**E-54 Regional Lift Station - RFCSP
Solicitation Number: CO-00537
Job No.: 22-2502**

**ADDENDUM 2
October 25, 2022**

SAWS JOB NO.	22-2502
JOB NO.	11500-51
DATE	SEPTEMBER 2022
DESIGNER	RM
CHECKED	DRAWN
SHEET	C2.00

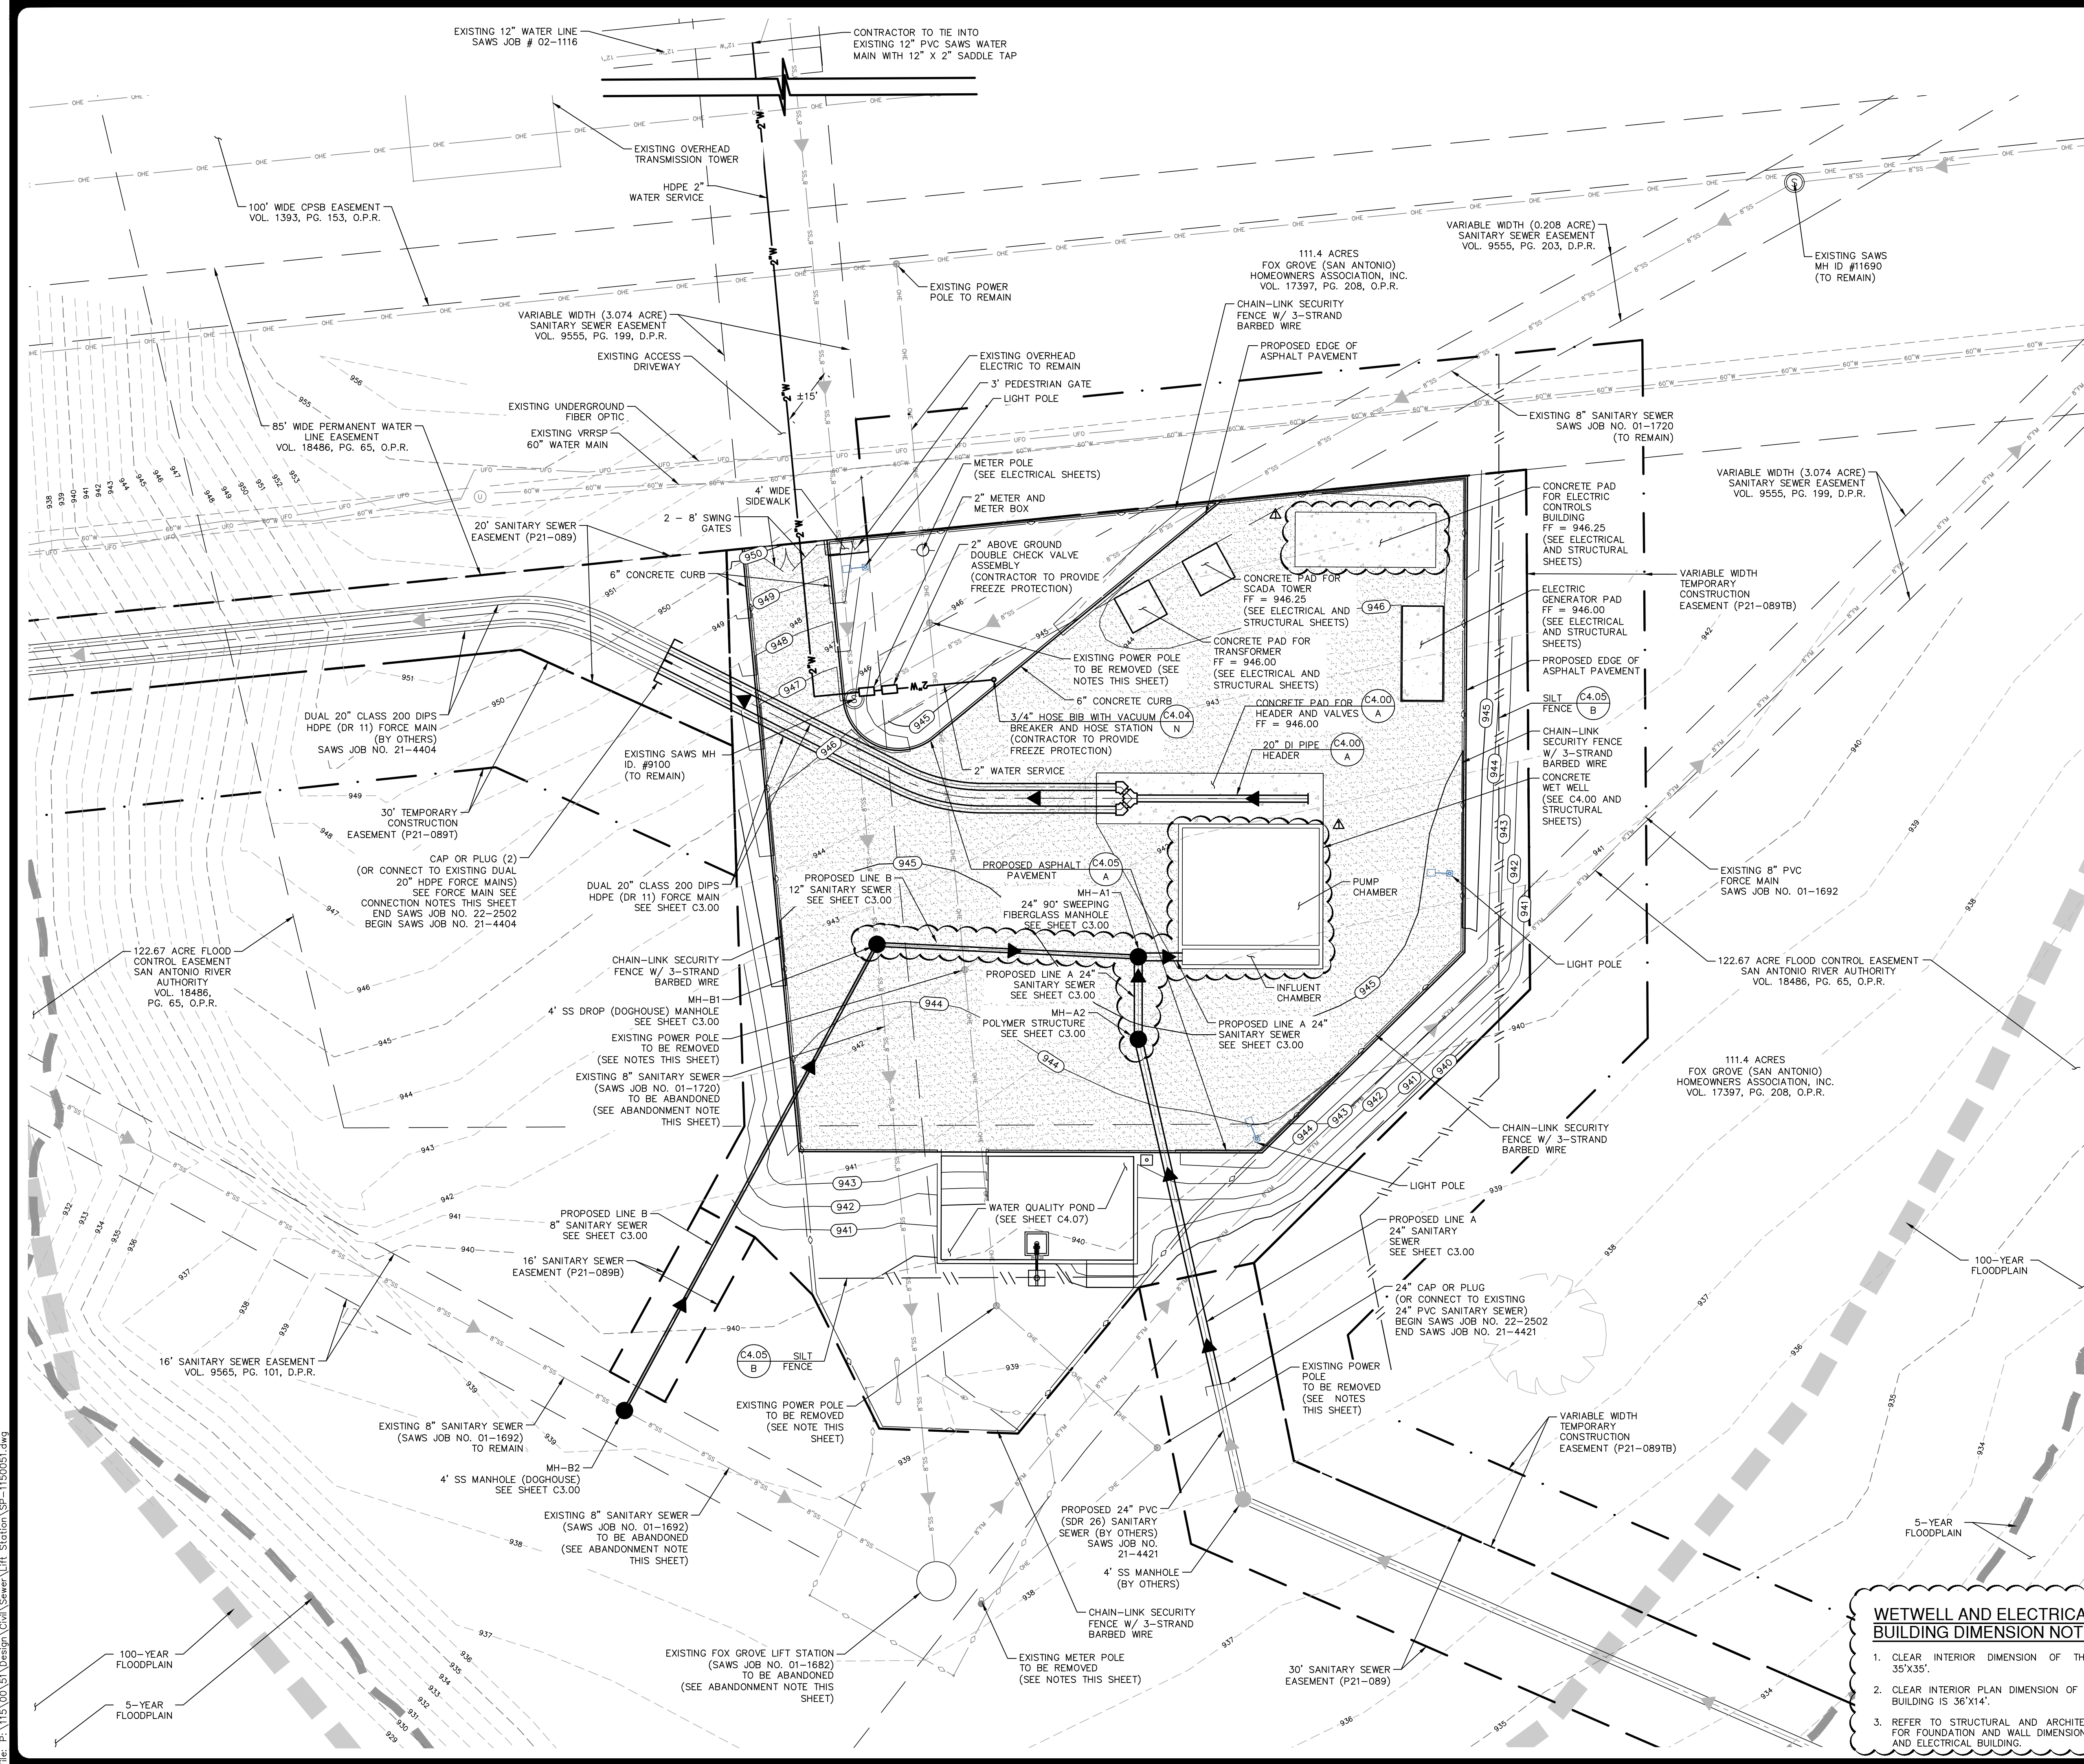
There are discrepancies between dimensions of Sheet E4.00 as compared to E10.00 as well as other electrical building plans. When scaling the foundation of the electrical building on E4.00, it gives a dimension of 32'x14'. Using the scale provided on E10.10 through E10.20 the foundations show to be 37'8"x15'8", same as shown for architectural plans. Site dimensional control Sheet C2.01 seem to indicate the building foundation is 32'x14'. Same goes for other structures on site having different dimensions between site dimensional control plan and individual structural plans. Please clarify which scales are to be utilized.

RESPONSE: Sheet C2.00, C2.01, Sheet C3.00, and E4.00 are revised to show correct interior electrical building and wetwell dimensions and dimensional controls of 36'x14' and interior wetwell dimensions of 35'x35', respectively. Contractor shall refer to structural drawings for foundation perimeter dimensions for these structures. See Changes to the Plans #1, #2, #3, and #9.
